TABLE OF CONTENTS
AC-24-26
PR-2018-001577, SI-2024-00994

SUBJECT: AC-24-26, PR-2018-001577, SI-2024-00994

This is an appeal of the EPC's decision to approve a Site Plan – EPC for the Double Eagle II (DEII) Airport. The request documents the existing, as-built airport facilities and proposes Design Standards required for future development at the DEII Airport under the NR-SU zone district. The NR-SU zone district requires a Site Plan that establishes allowable uses and development standards, that are negotiated at the EPC through the EPC application and the Site Plan. The Site Plan must also be in compliance with the Master Plan for DEII.

<i>Appeal of August 15, 2024 EPC decision to approve the Double Eagle II Site Plan</i>
--

BUILDING B: FBO OFFICE FACILITY

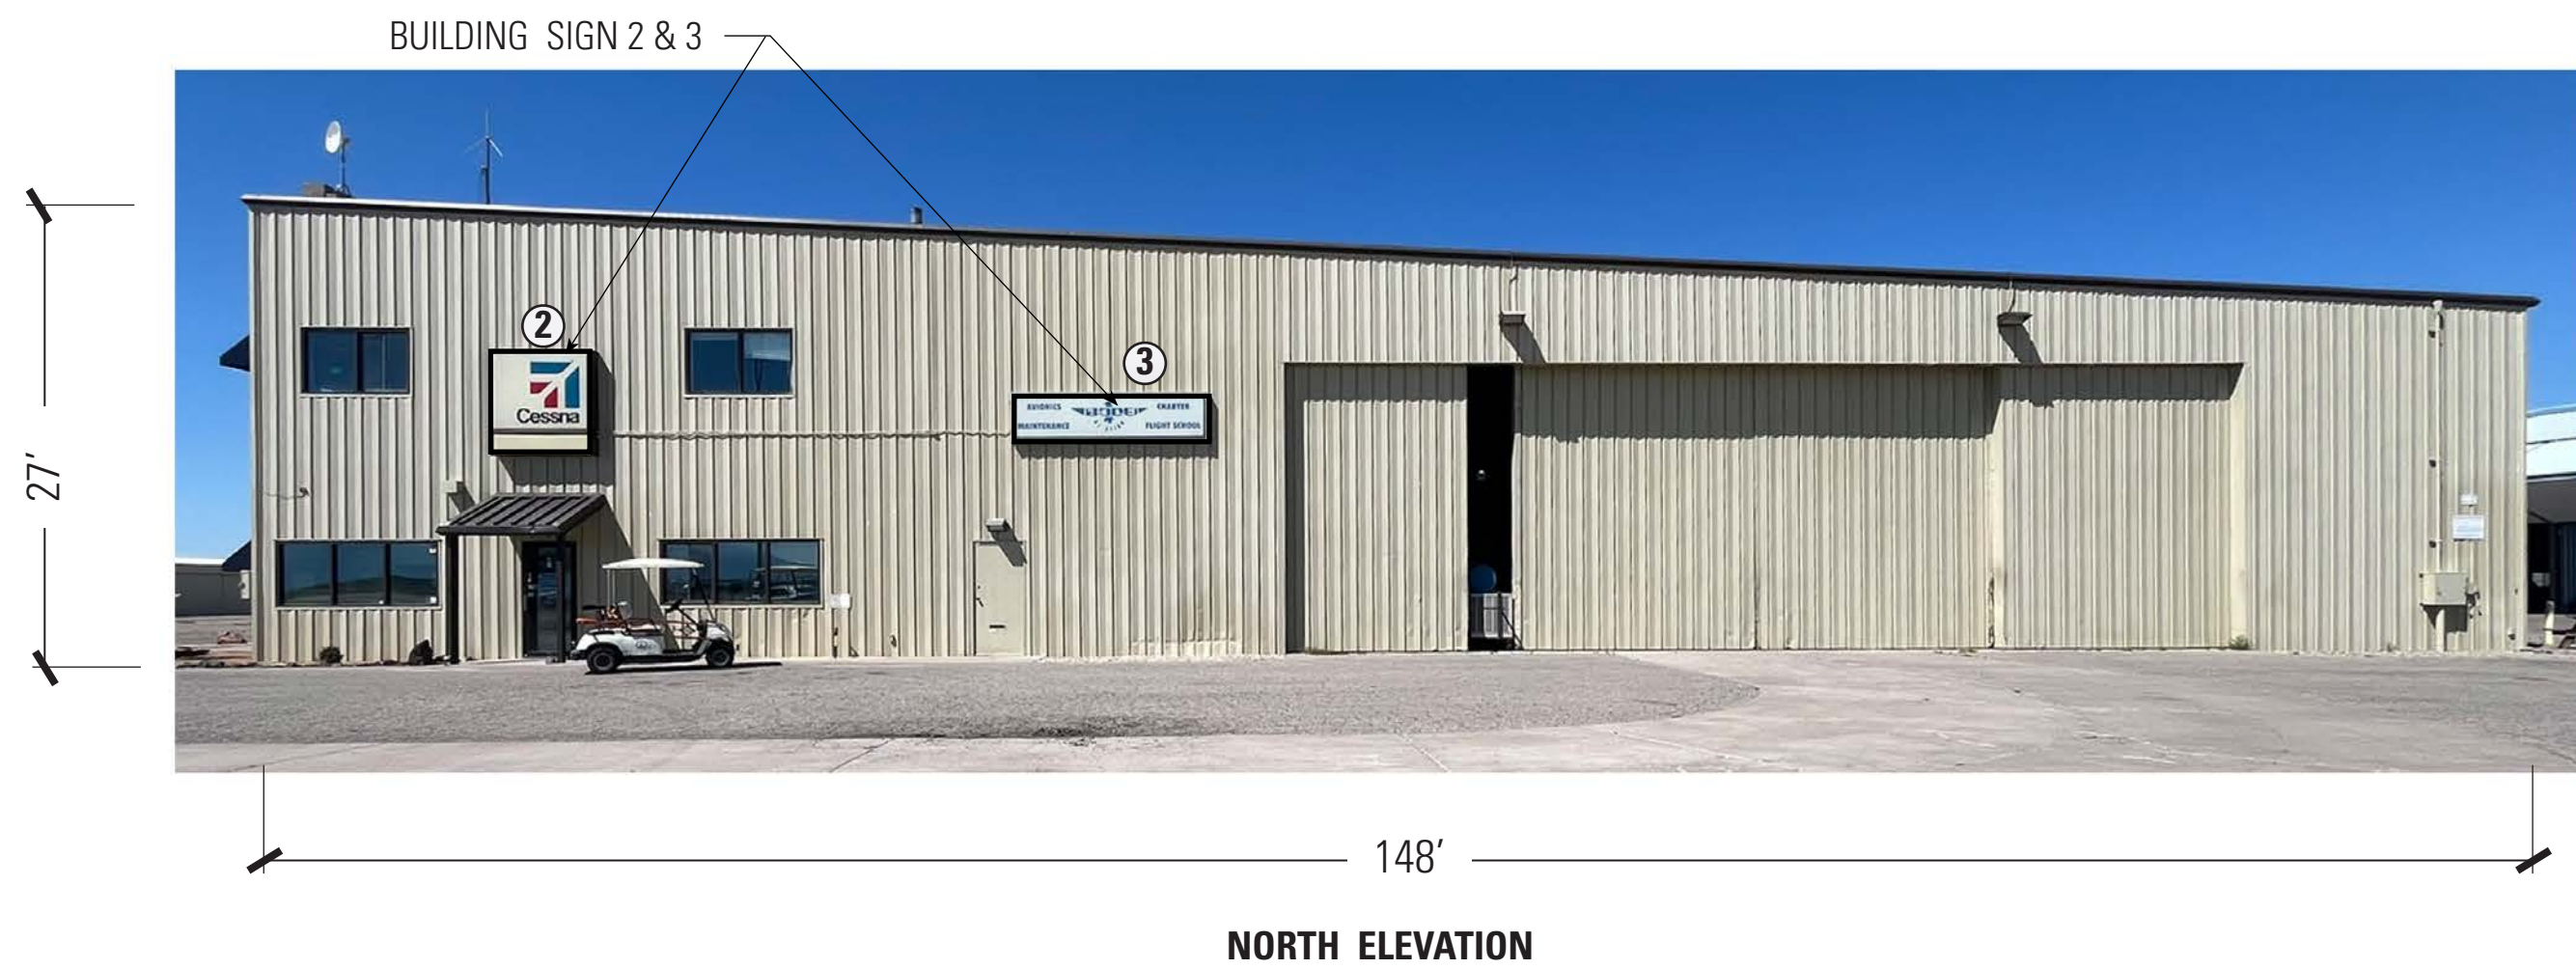
- E. The symbols next to the Utility Structure to the southwest of Building B shall be added to the legend on Sheet SDP2.1.
8. Development shall not occur east of the right-of-way (ROW) of Atrisco Vista Blvd.

BUILDING 01: T HANGAR ELEVATION

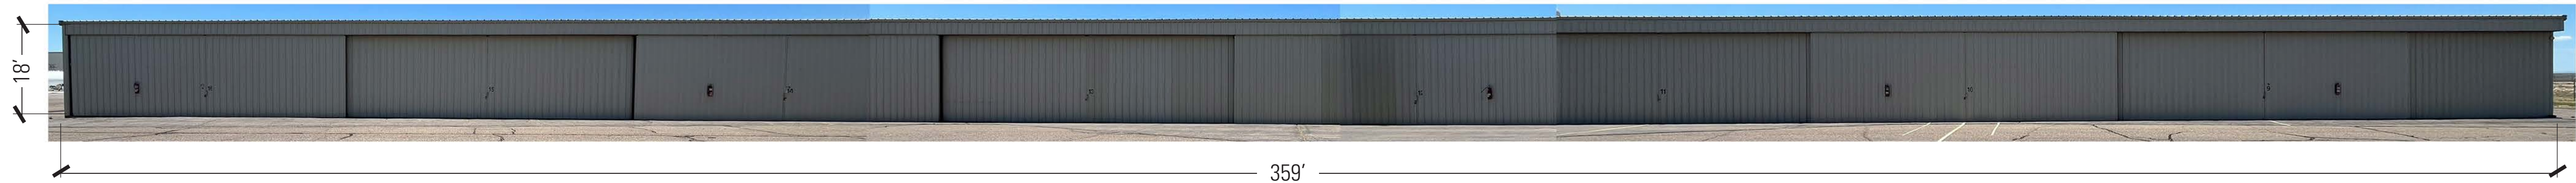
- I. Building length shall be added to the elevation depiction of Building O2 on Sheet AE3.11.
- 8. Development shall not occur east of the right-of way (ROW) of Atrisco Vista Blvd. and adjacent to MPOS or within 330-feet of the Petroglyph National Monument.
